VILLAGE OF GERMANTOWN
N112 W17001 MEQUON ROAD
GERMANTOWN, WI 53022

MEETING:	PLAN COMMISSION
DATE AND TIME:	MONDAY, APRIL 8, 2019 6:30 p.m.
LOCATION:	Germantown Village Hall Board Room

SHEET:
C1.0

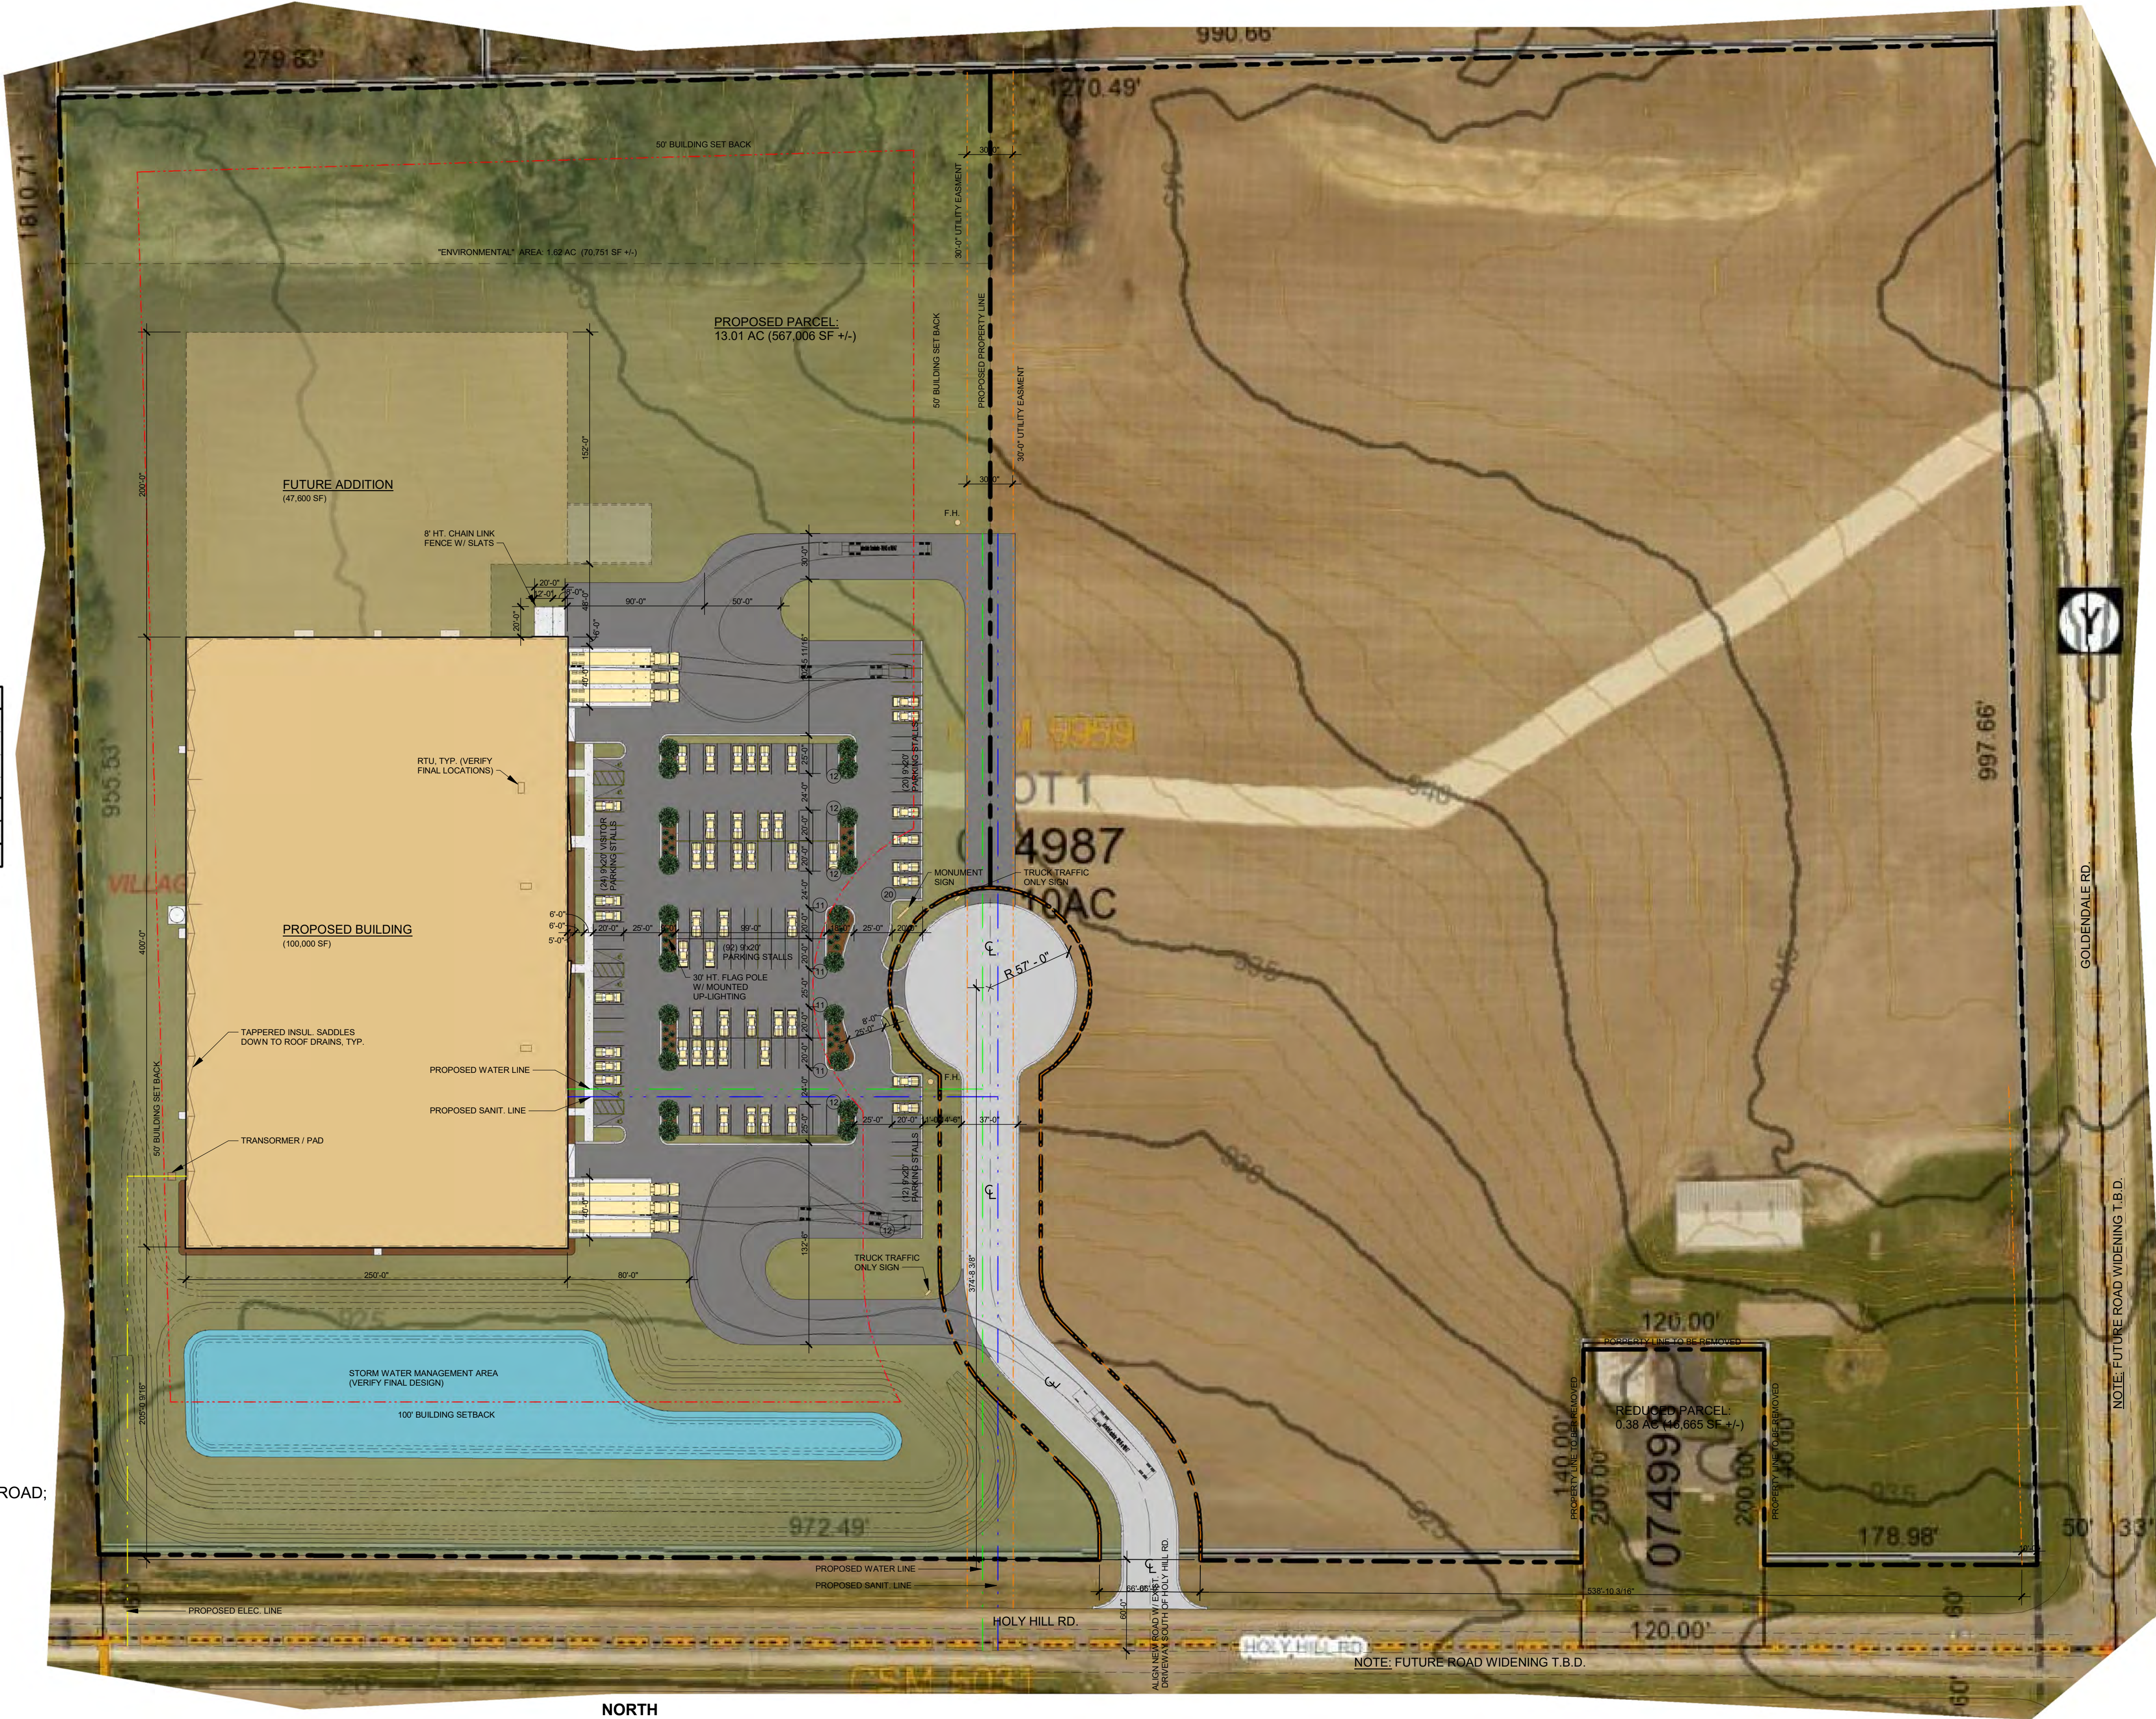
- q. Sidewalk that is back of curb is to be a minimum 6 feet in width. Currently it is shown as having 5-foot widths on the plans. **Sidewalk width is dimensioned on sheet C1.0 as 6'-0"**

SHEET
C-4
of
C-18

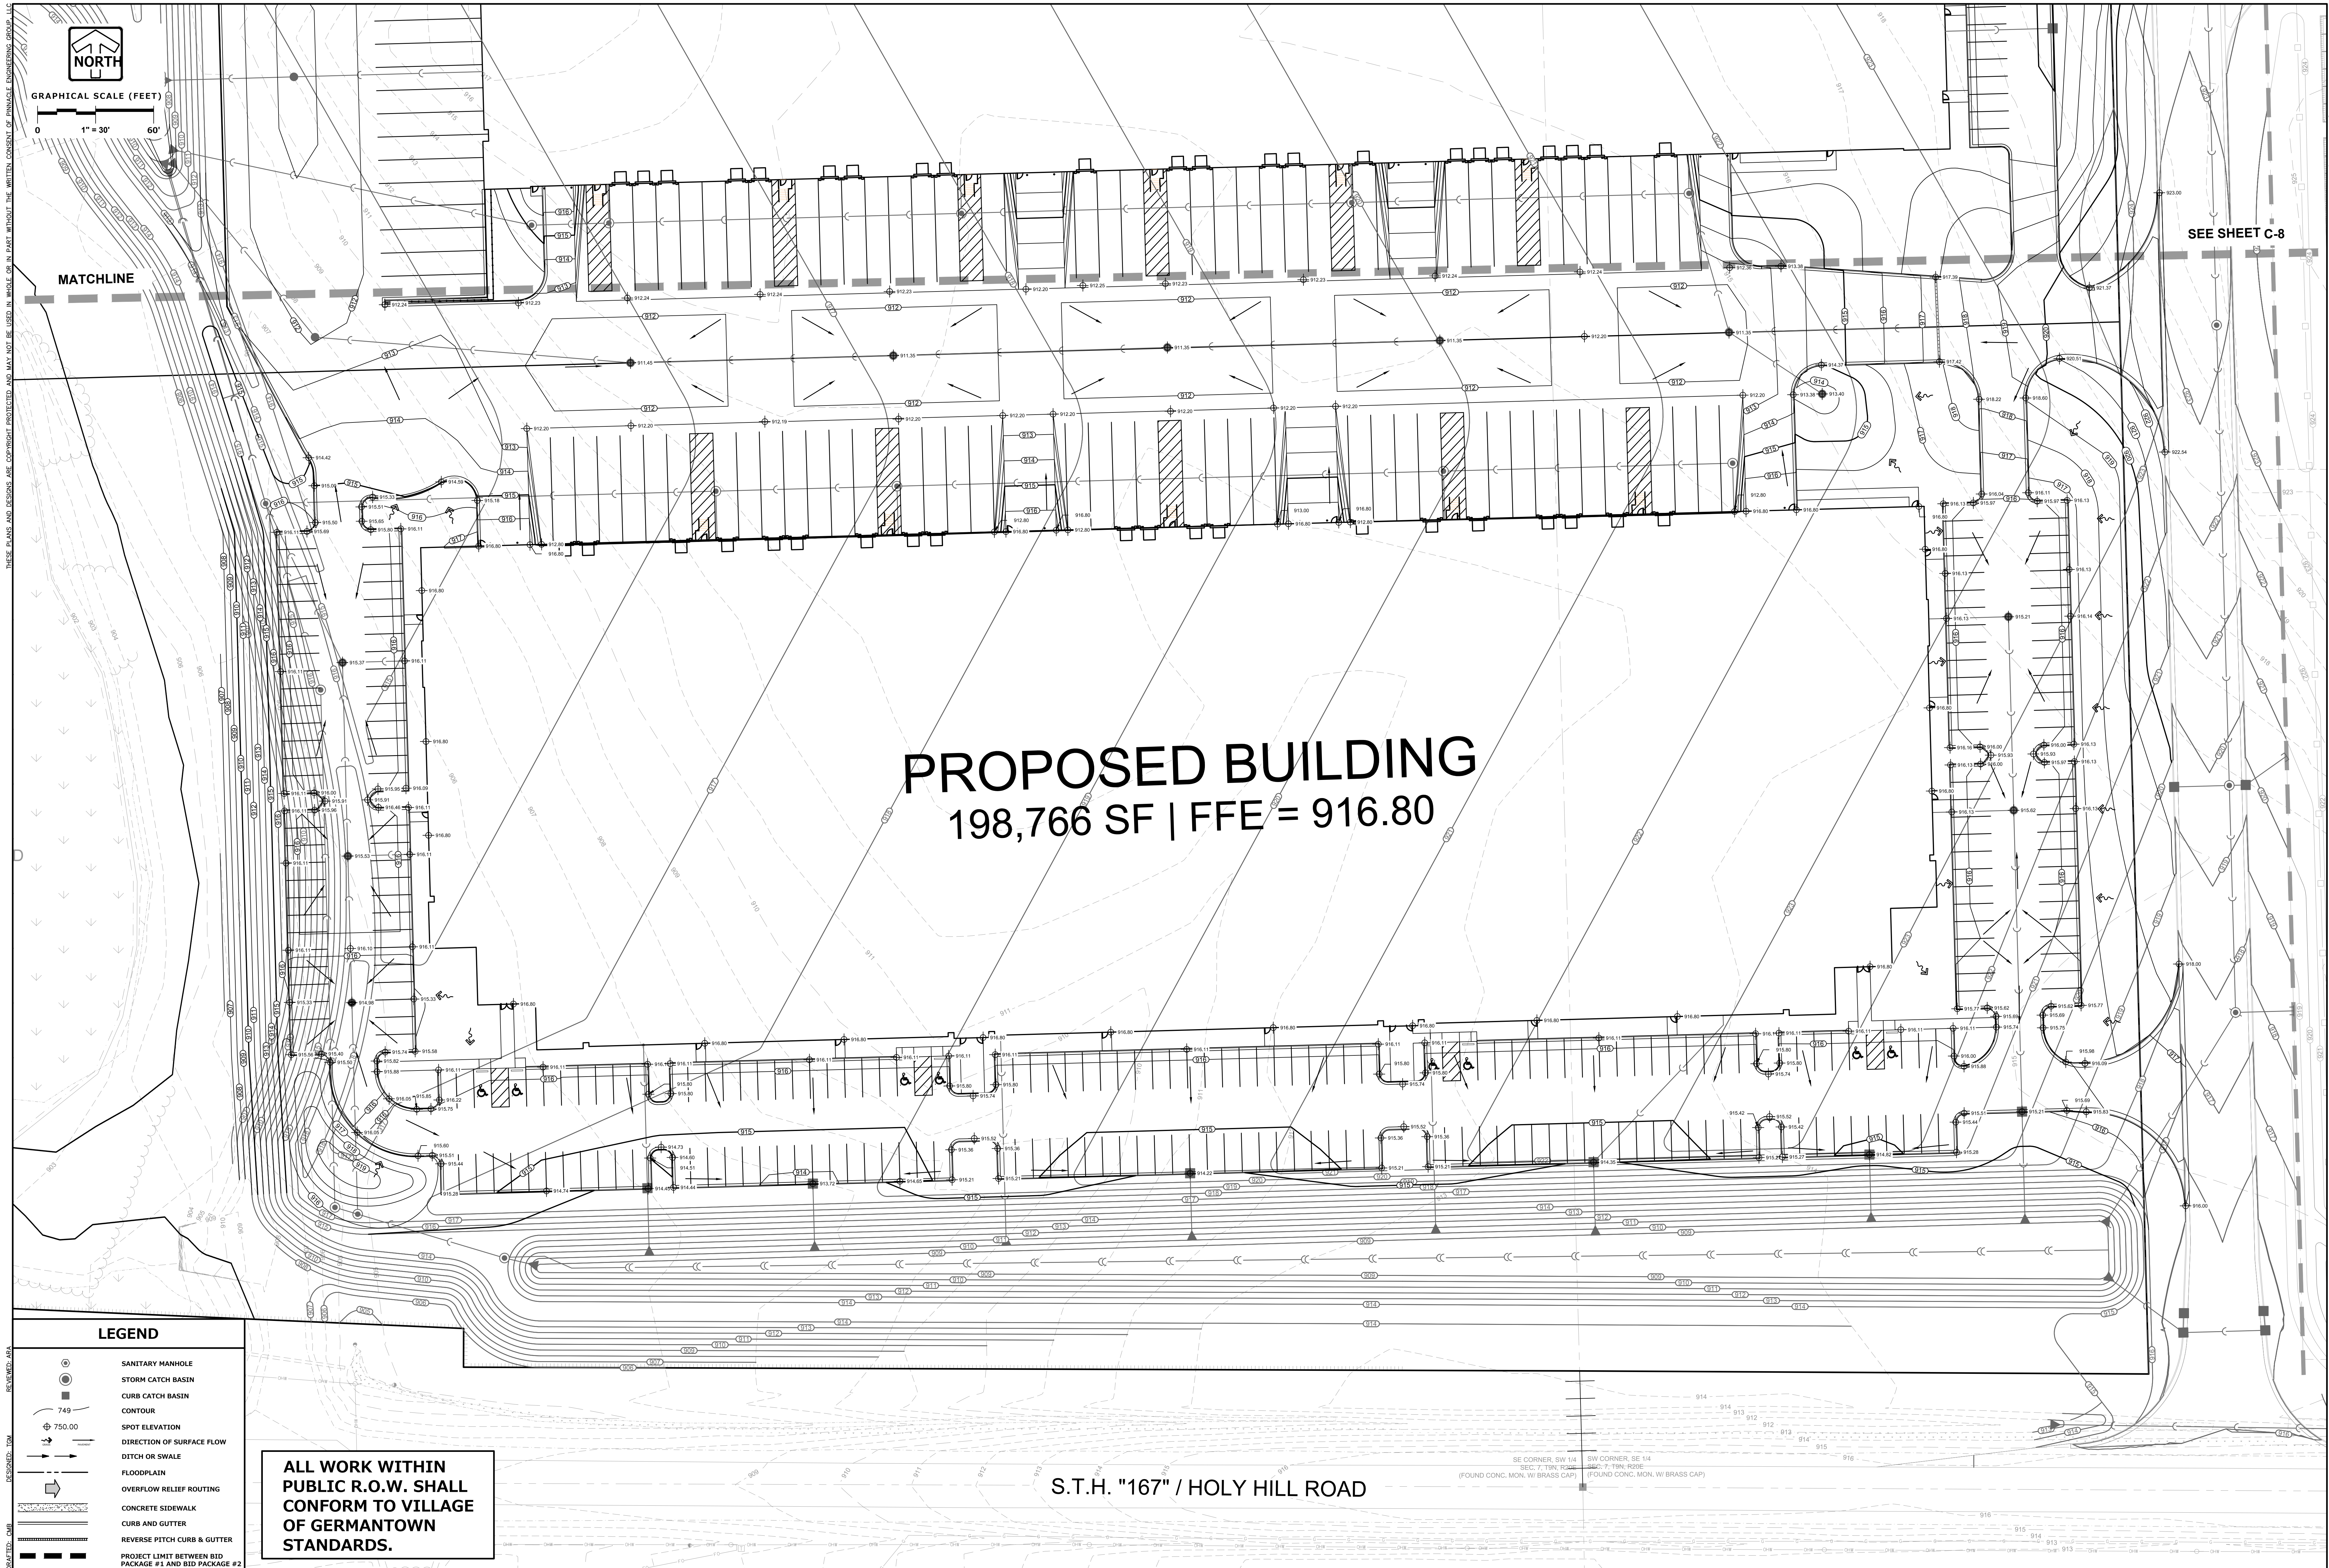
- o PINNACLE – Sidewalk that is the back of curb has been widened to 6 feet. See Sheets C-4 and C-5.
- l) Pavement design should be modified. Currently the Light Duty Pavement is called out to have one (1), 3.5 inch lift of asphalt designated 5MT 58-28S (9.5mill). The Light Duty Pavement is required to have two (2) inches of 3LT 58-28S asphaltic

C-102

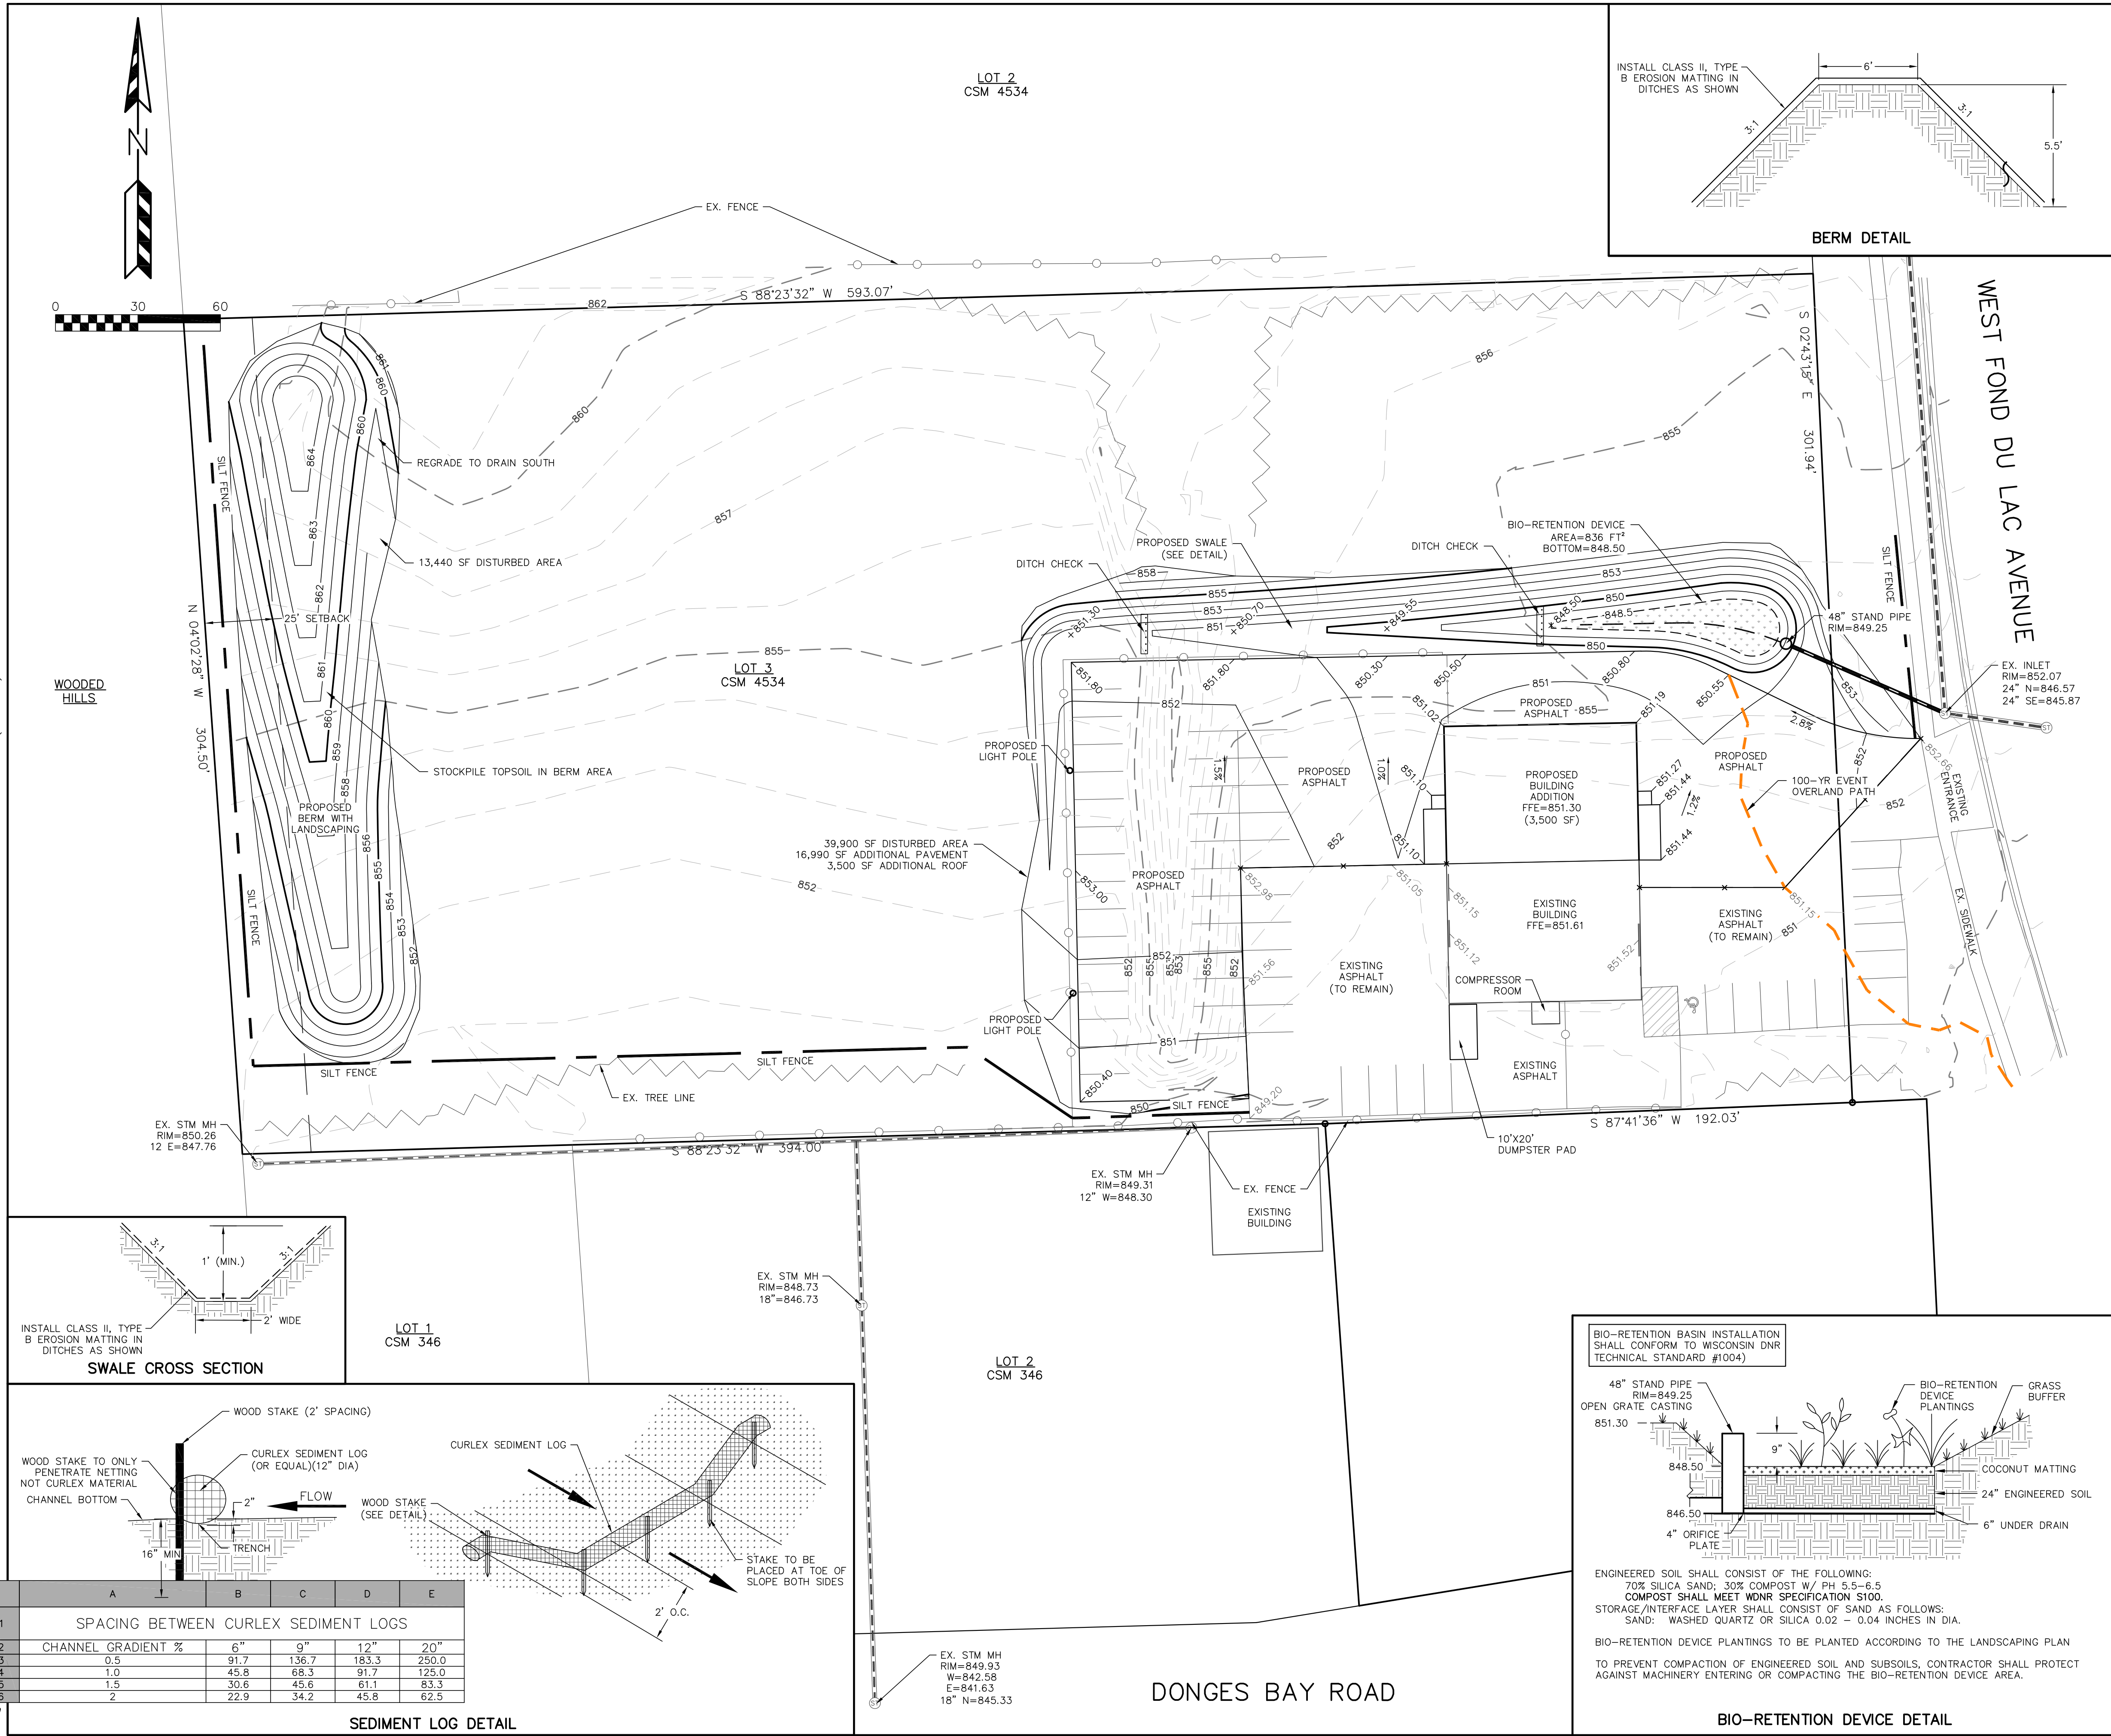
As shown on the site plan (Sheet C-102), existing pavement including five (5) parking stalls are located in the Fond du Lac Avenue right-of-way. While other existing developed features on the site do not comply with current zoning code requirements, the continued use of and improvements to features that are not located within the property boundary needs to be remedied.

With that in mind, it's understandable that the owner wants to secure this parking area with a chain link fence. However, the Applicant indicates on the site plan (Sheet C-102) that the proposed 6' high wooded fence is intended to be installed at future date to be determined. Staff supports the proposed fence installation provided it is installed within a reasonable time, i.e. within (18) months after completion of the 3,500 sqft building addition.
